Re: Yale Retail

Request for Certificate of Occupancy

Transportation Development Final Inspection

TCL-1

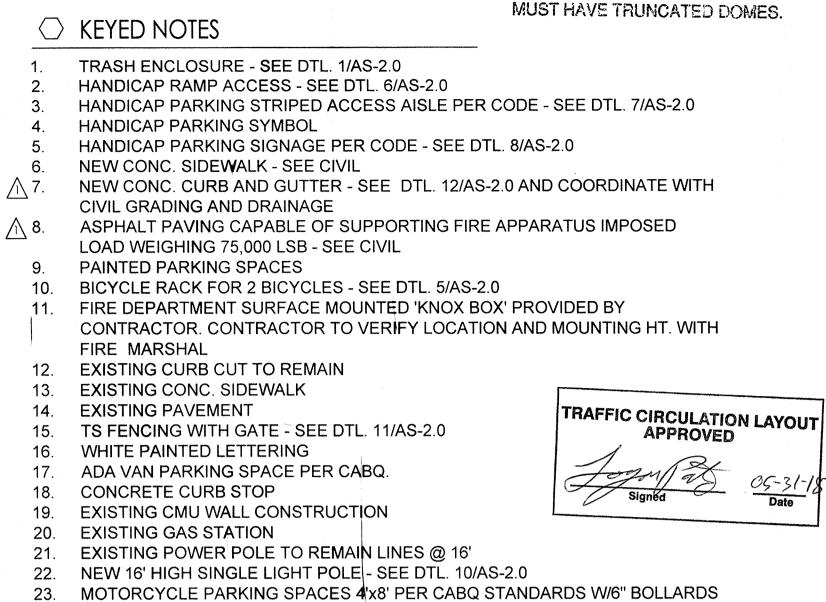
- Please redline plan to reflect changes to site.
- Bike rack does not meet city standards (See attached Bike rack standards)
- Update ADA signs to reflect current language and add parking bumpers.

- Please add work order #. Alley Paving.
- Remove compact from motorcycle stall and stripe for two MC stalls.
- Add concrete connection from sidewalk to Building entrance for ADA access.
 (Maximum running slope 8.0% Max cross slope 2.0%)
- Remove trash container next to compact stall.
- Water meter is located within compact parking stalls. Are the meters Traffic rated? Please contact Water Authority.
